Access Compliance Report

Public Rights-of-Way

(Curb Ramps)

Intersection ID: 32314	Main Street: CAMDEN_TRAIL_CT	Cross Street: NEW_PROVIDENCE_LN	Location: SW
ADA ID: 3204038DE4C0	Ramp Type: Perp	Initial Pass/Fail: Fail	Overall Compliance: No
		Severity Score: 12.5

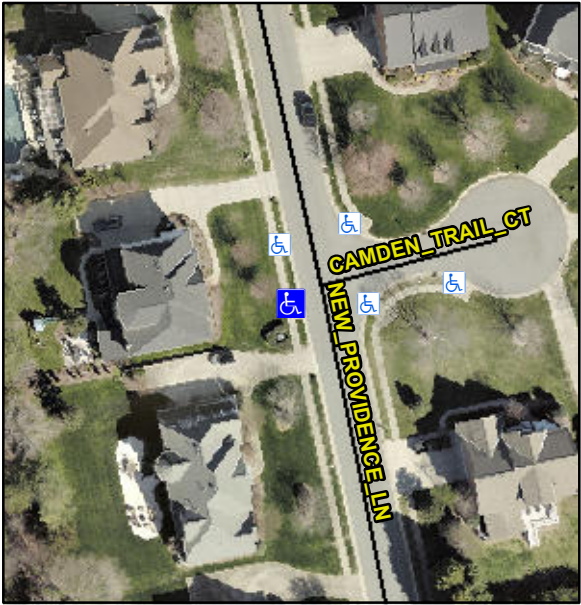
Codes/Mitigation Info/Possible Solution			Field Measurements/Component Compliance		
	Possible Solutions:		Compliance	Description	Data
	Remove & Replace Entire Ramp.		No	Ramp Length (in)	48.0
			Yes	Ramp Width (in)	48.0
			N/A	Flare Type LT	N/A
			N/A	Flare Slope LT (%)	N/A
			N/A	Flare Traversable LT?	N/A
			N/A	Landing Length (in)	N/A
			N/A	Landing Width (in)	N/A
			N/A	Landing Slope (%)	N/A
			N/A	Landing X Slope (%)	N/A
			N/A	Landing Curb? (Y/N)	N/A
			N/A	Shared Landing?	N/A
			N/A	Gutter Ponding?	N/A
			N/A	Gutter Lip Ht (in)	N/A
			No	Painted X Walk1?	N/A
				X Walk 1 Direction	To E
			N/A	X Walk 1 Width (in)	N/A
				X Walk 1 Slope (%)	4.5
				X Walk 1 X Slope (%)	0.0
			N/A	Ramp inside XWalk1?	N/A
<p>Surveyor Notes:</p> <p>N/A</p> <p>PROW/ADA:</p> <p>Not Found, R304.2.2</p>			N/A	Flare Type RT	N/A
			N/A	Flare Slope RT (%)	N/A
			N/A	Flare Traversable RT?	N/A
			N/A	DWS Provided?	N/A
			N/A	DWS Contrast?	N/A

N/A	DWS Length (in)	N/A
			N/A	DWS Full Width?	N/A
			N/A	DWS Offset (in)	N/A
			N/A	Gutter Slope (%)	N/A
			N/A	Gutter X Slope (%)	N/A
			N/A	Painted X Walk2?	N/A
				X Walk 2 Direction	N/A
			N/A	X Walk 2 Width (in)	N/A
				X Walk 2 Slope (%)	N/A
				X Walk 2 X Slope (%)	N/A
			N/A	Ramp inside XWalk2?	N/A
			N/A	Clear Space?	N/A
			N/A	Clear Space to XWalk (in)	N/A
			N/A	Storm Grate/Utility Hazard?	N/A
				Storm Grate/Utility Type	N/A
<p>Total Cost:</p> <p>\$ 1850.00</p>			N/A		N/A
			Yes	Surface Condition? (G/P)	Good
